Re: Cherokee Nation WW Hastings Replacement Hospital - Addendum 02 Narrative

Following is a list of revisions included in Addendum 02.

PROJECT PHASE:
BID PACKAGE 02
(SITE DEMOLITION AND UTILITIES)

C6-204

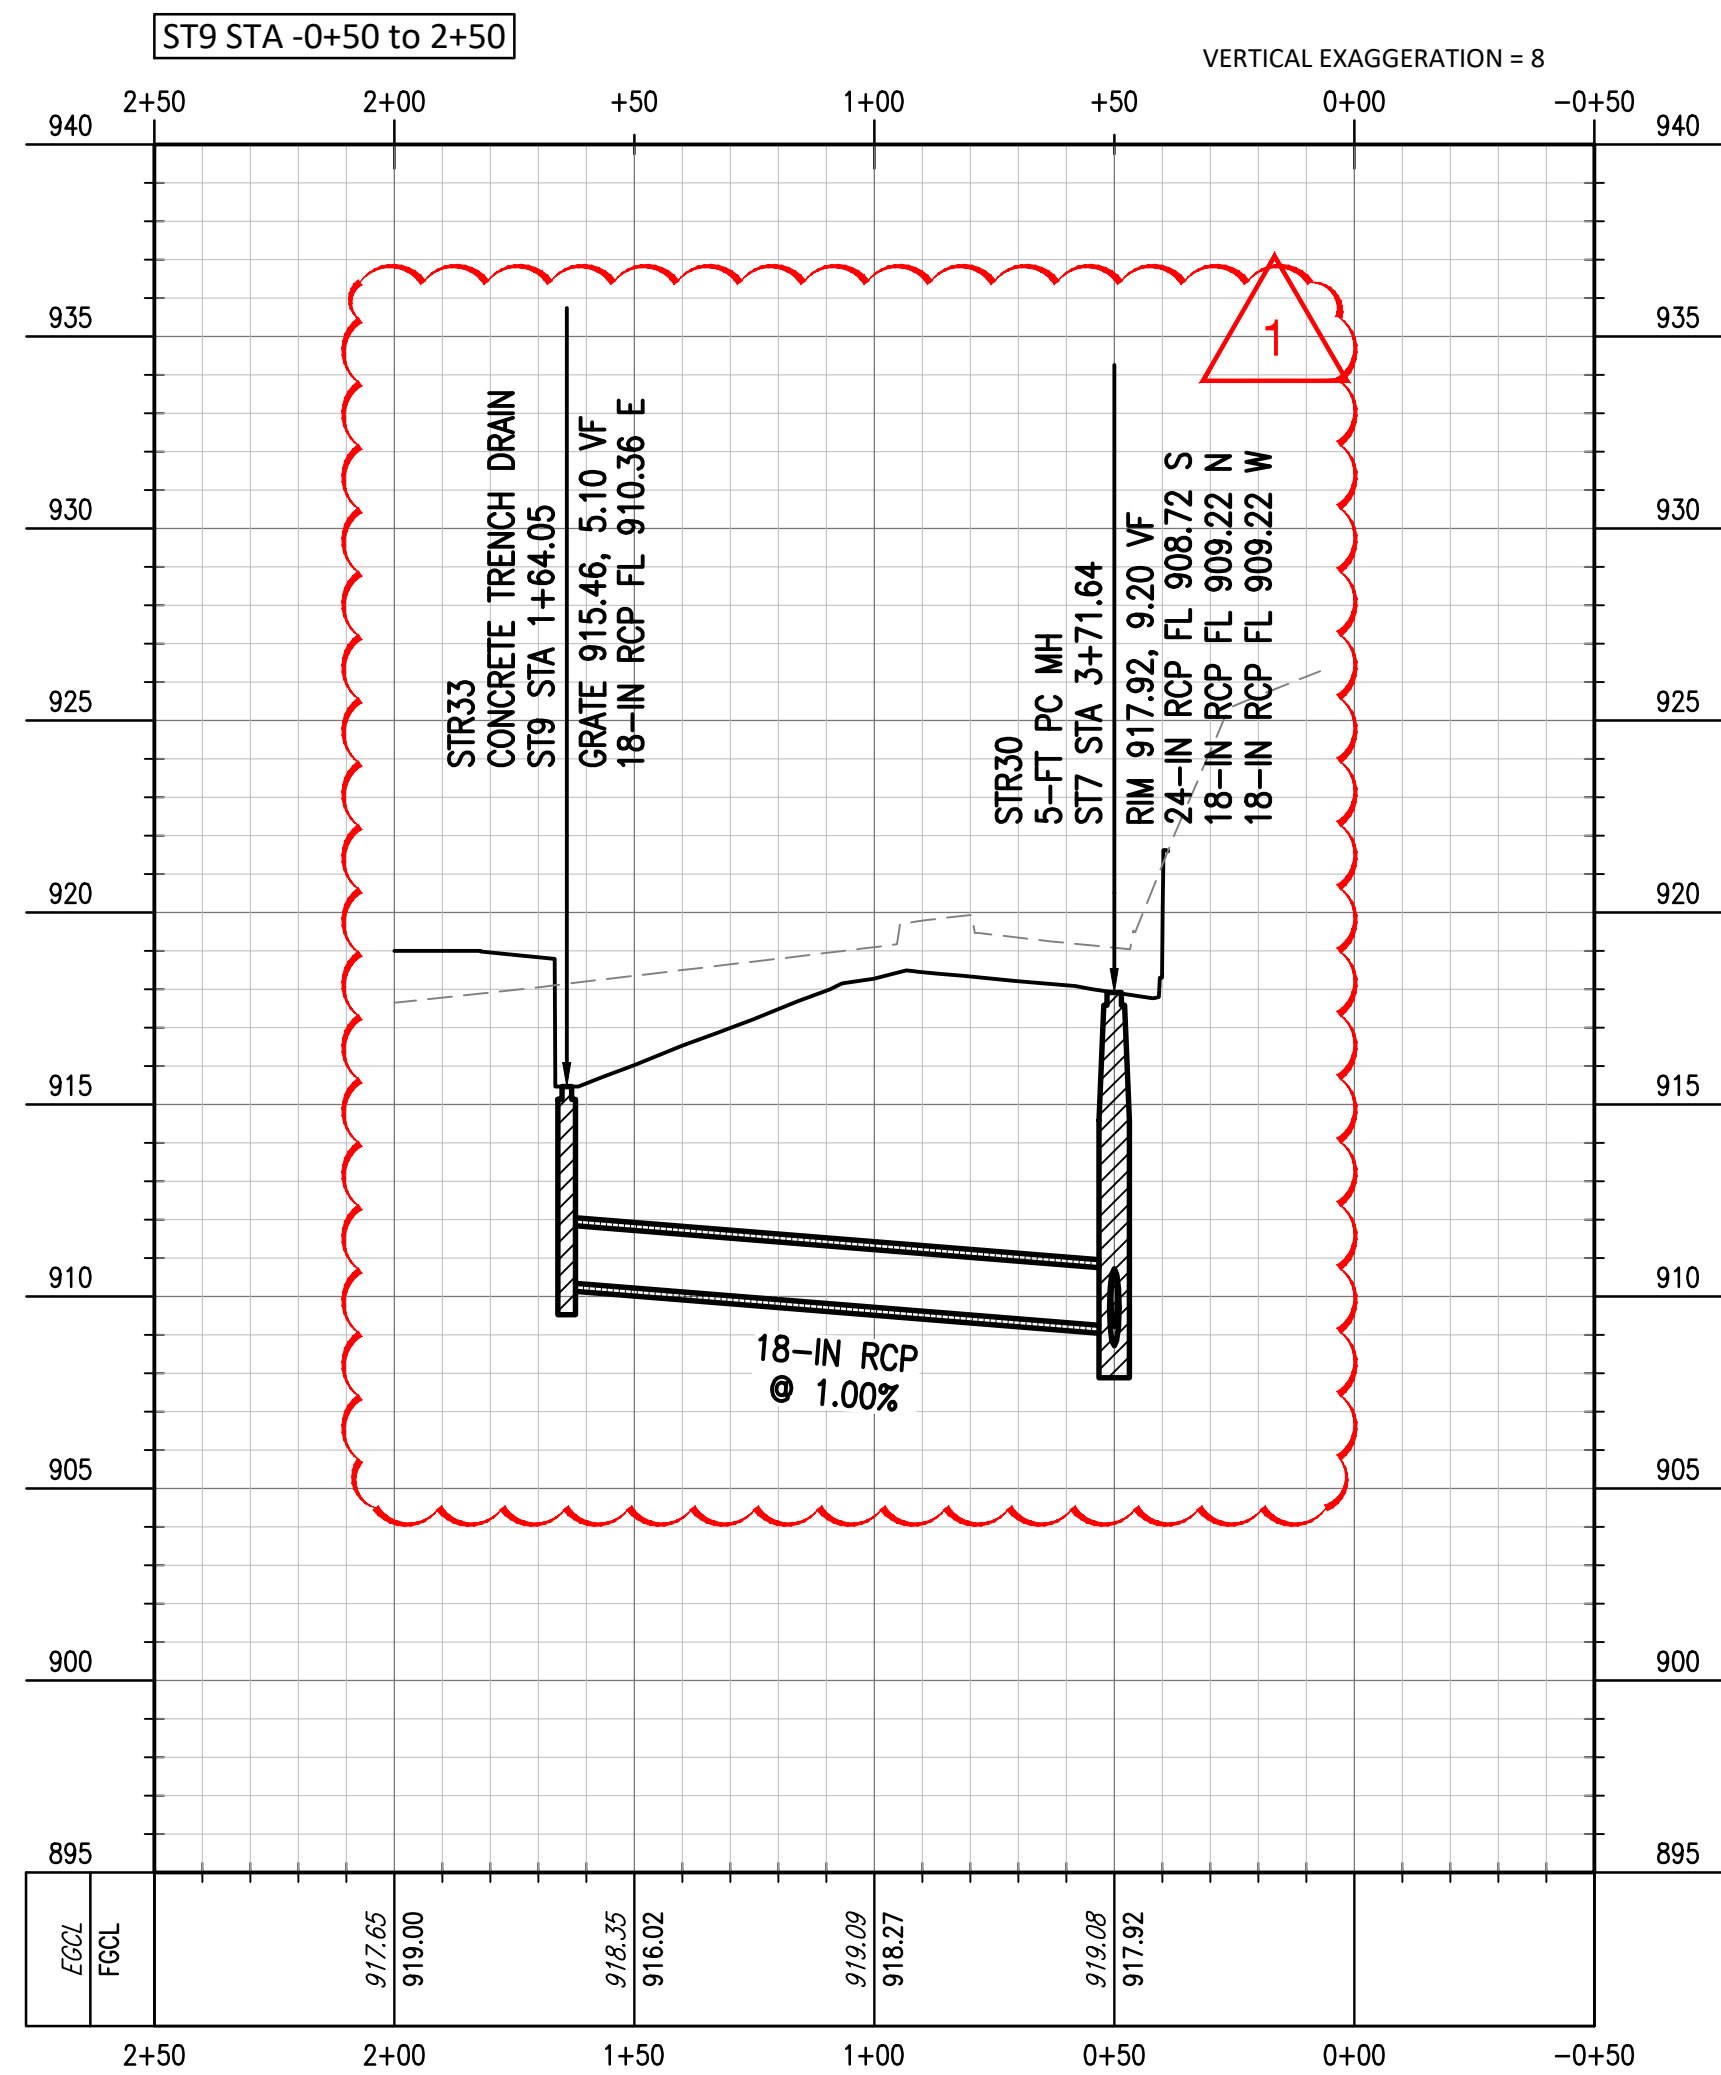
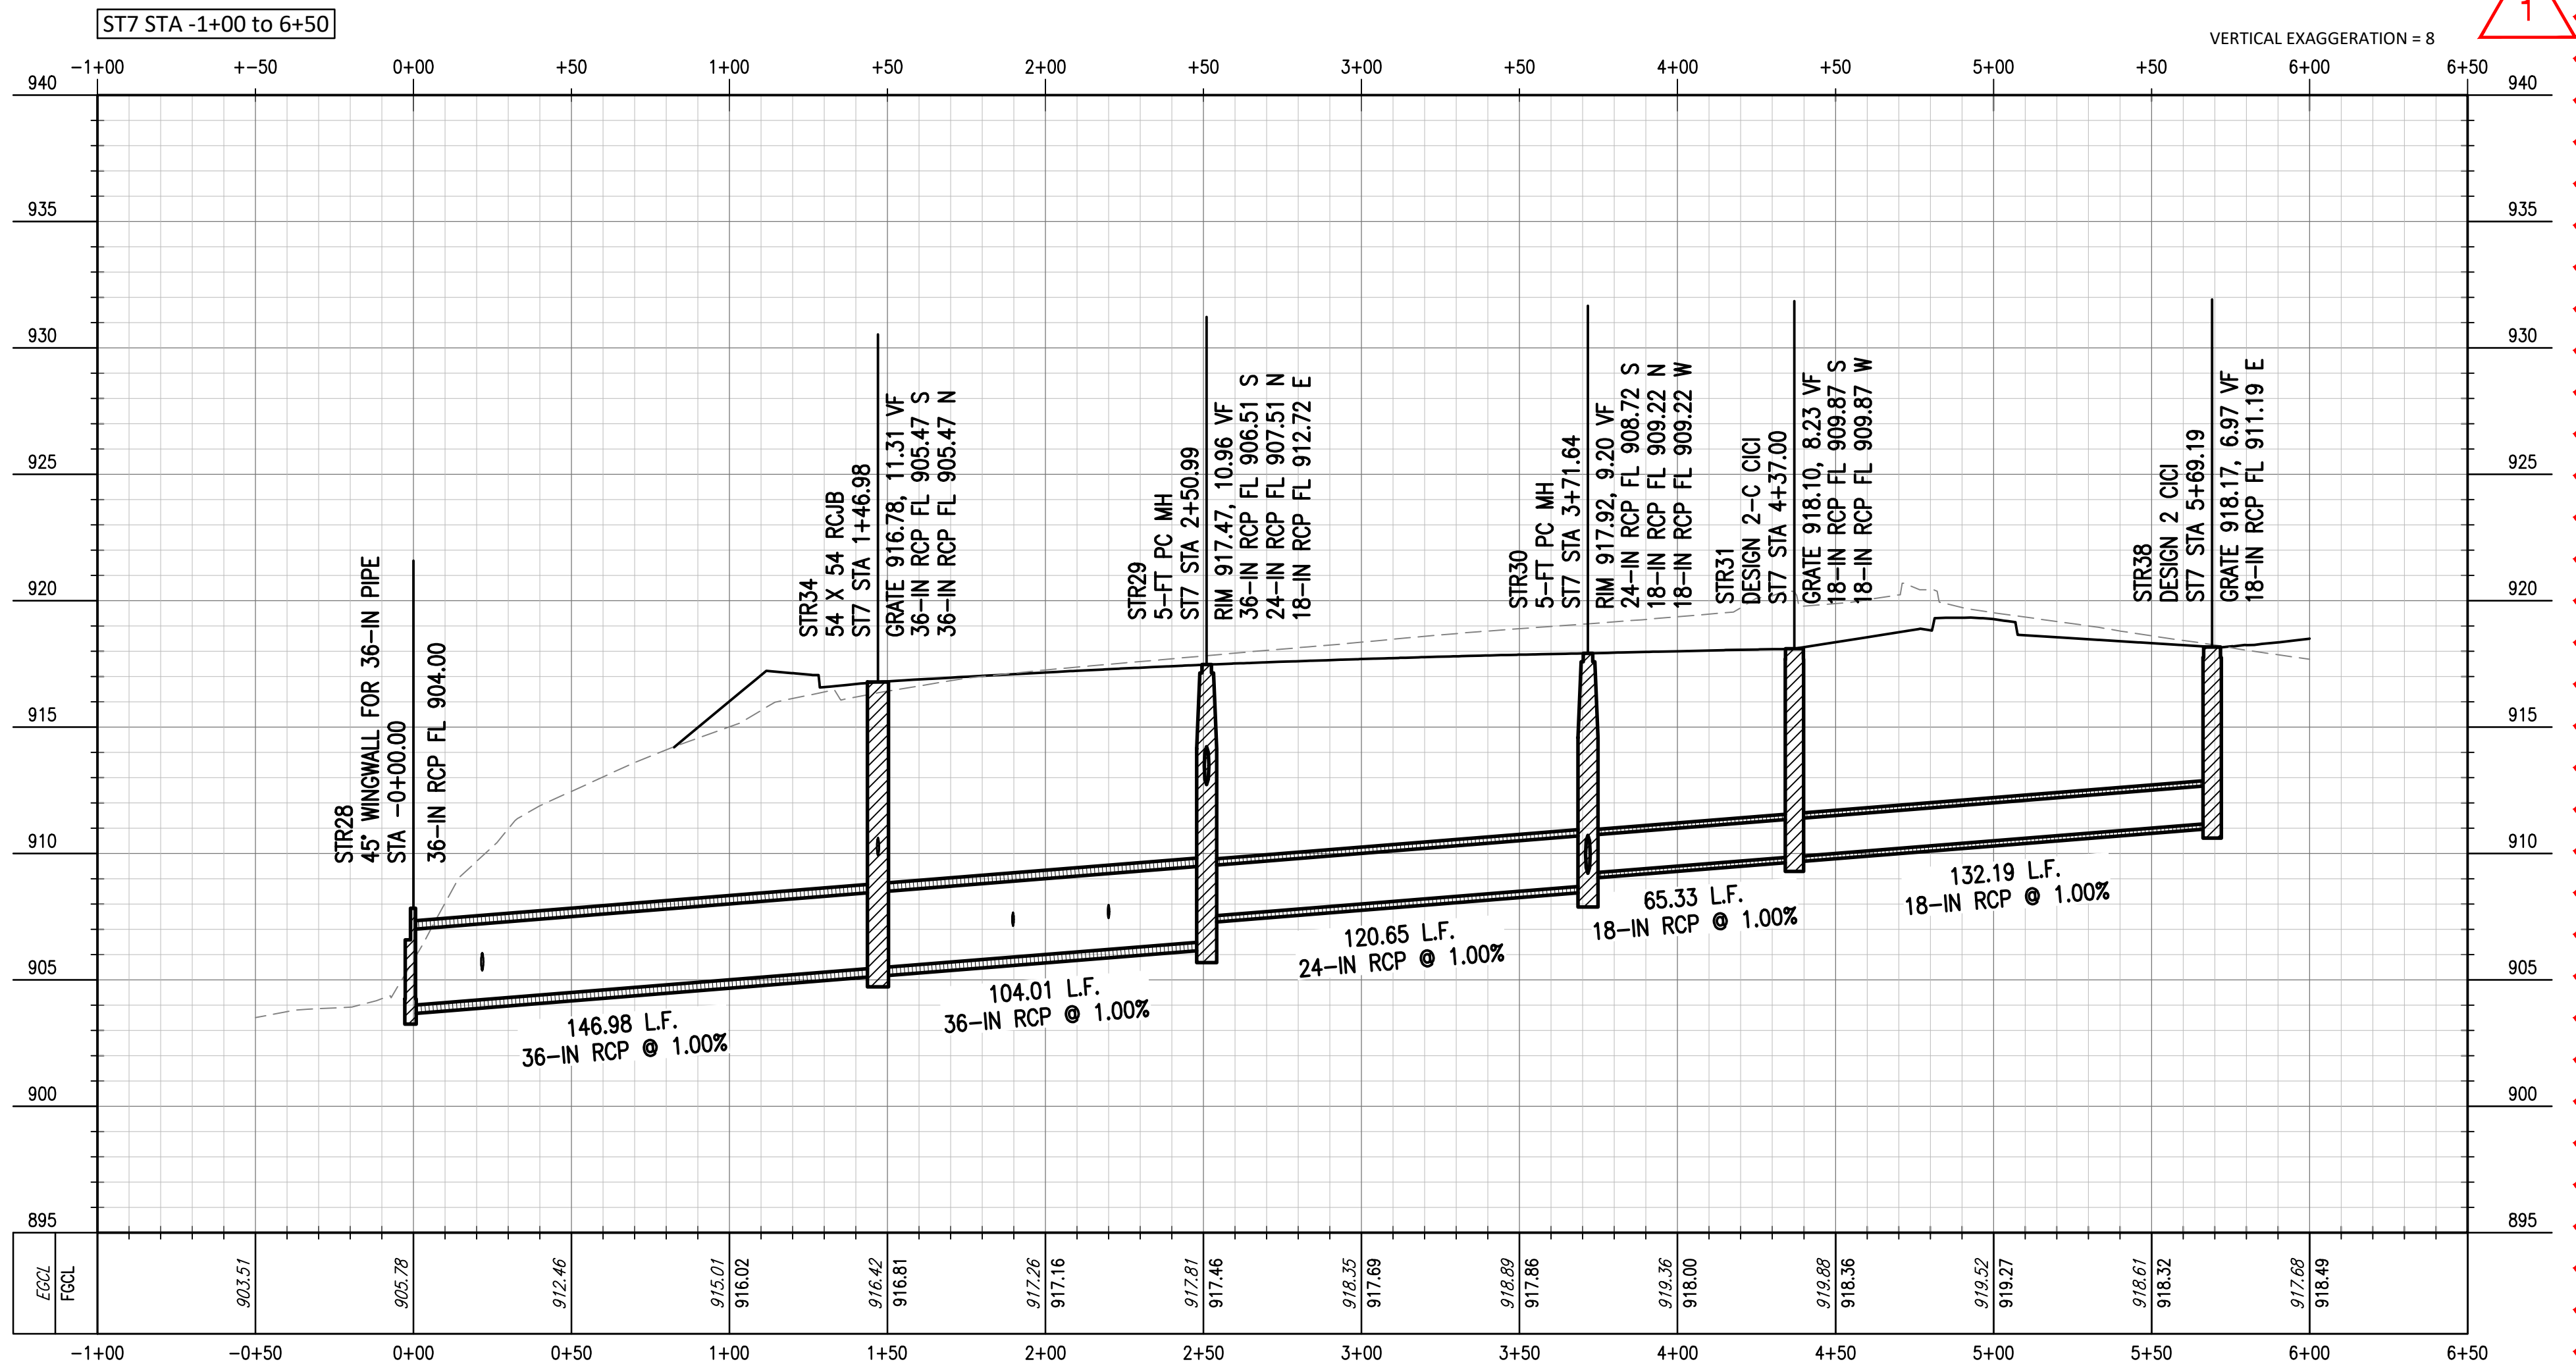
- C6-204 - Added label to STR17 in ST6 profile.
Added label to 45 deg bend in ST8 profile.
Added profile for ST2 to provide a profile of the existing storm sewer to remove from under the Central Energy Plant.
The storm sewer in ST7 profile was lowered so that drainpipes on the upstream end can pass under the 16-in water line.
Added STR38 to ST7 profile.
The pipe from STR33 to STR30 was lowered to pass under the 16-in water line.
